BOARD OF COUNTY COMMISSIONERS
ORANGE COUNTY, FLORIDA
IFB #Y19-720-CH; ADDENDUM NO. 5

HOLDEN AVENUE – FROM JOHN YOUNG PARKWAY
TO ORANGE BLOSSOM TRAIL (US 441)

This addendum is hereby incorporated into the bid documents of the project referenced above. The following items are clarifications, corrections, additions, deletions and/or revisions to and shall take precedence over the original documents. Underlining indicates additions, deletions are indicated by ~~strikethrough~~.

SHEET NO. 105

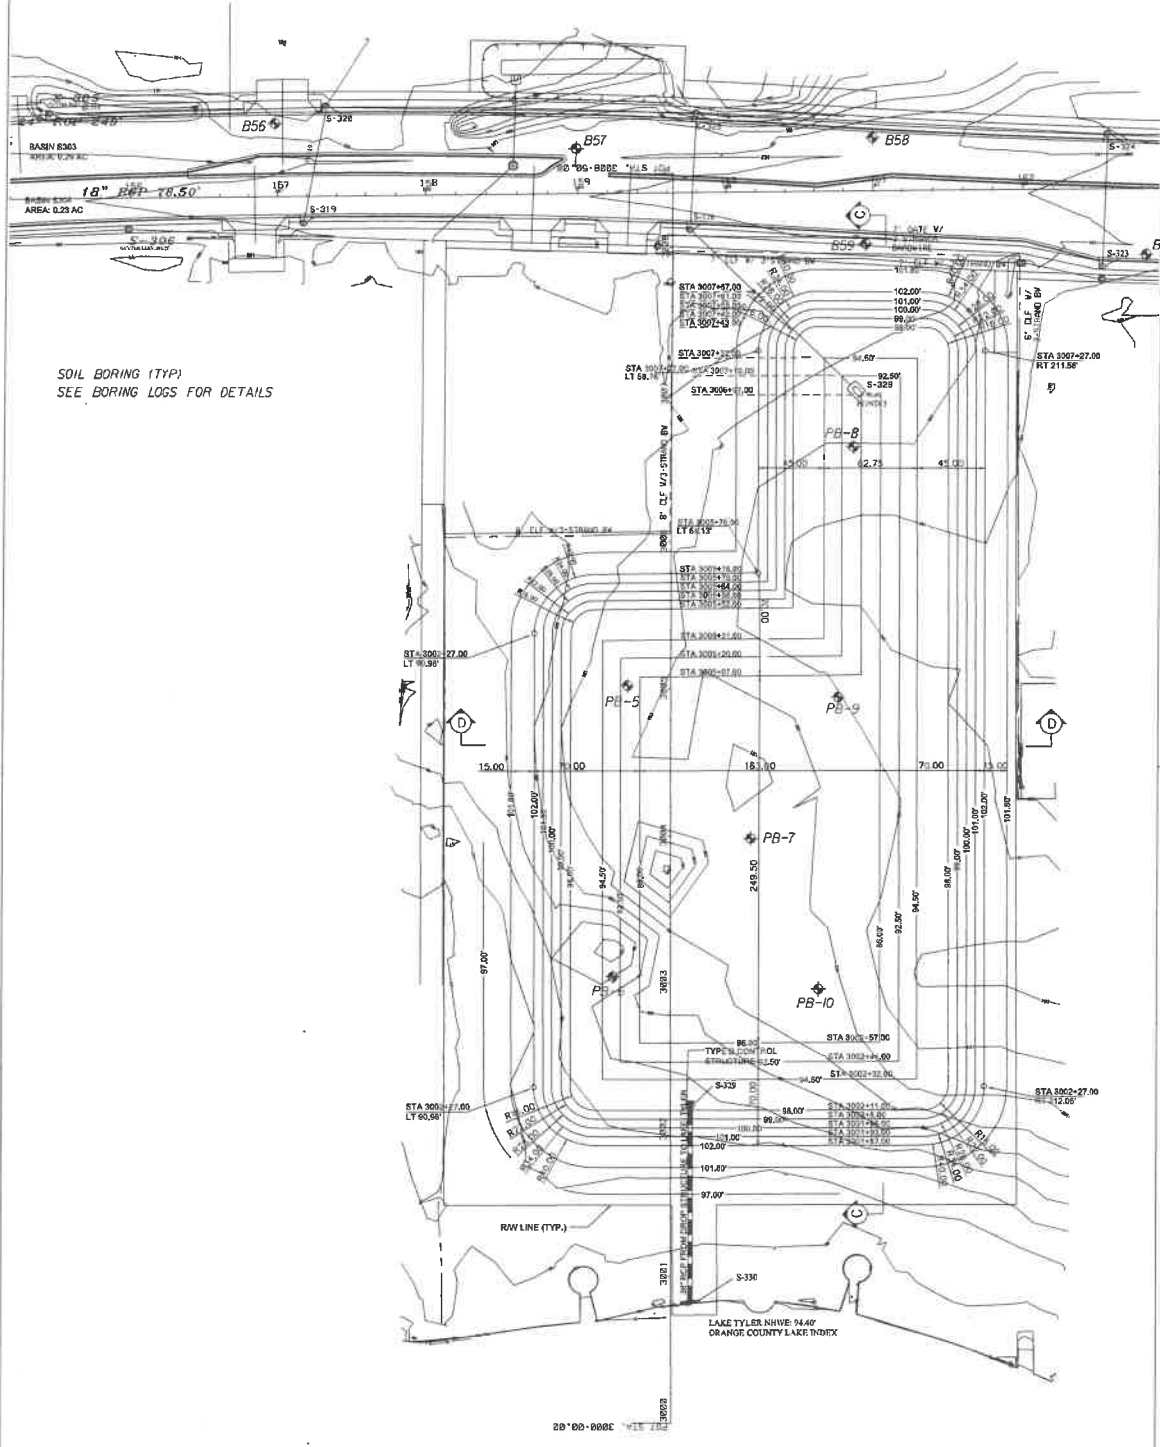
19. **Question:** S-330: Plan notes on drainage structures page 105 states Contractor is to submit shop drawing or detail for reconstruction of the existing concrete sea wall. Will this drawing/detail be required to be designed, signed and sealed by a PE or will the Contractor submittal be accepted? Is there access to this connection location presently so the existing sea wall can be inspected?

27. **Question:** S-330: Drainage structure sheet, plan page 105 does not include the profile of the existing sea wall and detail for installation of the proposed 36" head wall in relation to it. Is the proposed 36" head wall to be constructed on the existing sea wall or integrated into it? Is it to be installed in front of or behind the existing sea wall? Or is the head wall required at all? If the head wall is to be installed in front of the sea wall what is the distance from the front of the wall? More details needs to be provided for this installation so that accurate shoring, dewatering, and installation costs can be included. Please clarify this issue and/or provide additional details.

NOTE: Contractor shall specify casting schedule and curing for installation and removal of form of wall (removed for removal of form match existing wall. Contractor shall submit shop drawing which details and specifies how existing wall will be constructed at each location required. Cost to be included in cost of S-330.

Answer: S-330 shall be constructed integral to the existing wall. The existing wall shall be removed/reconstructed to the extent necessary to build S-330. A shop drawing of the means to accomplish the work shall be submitted for approval prior to the work taking place.
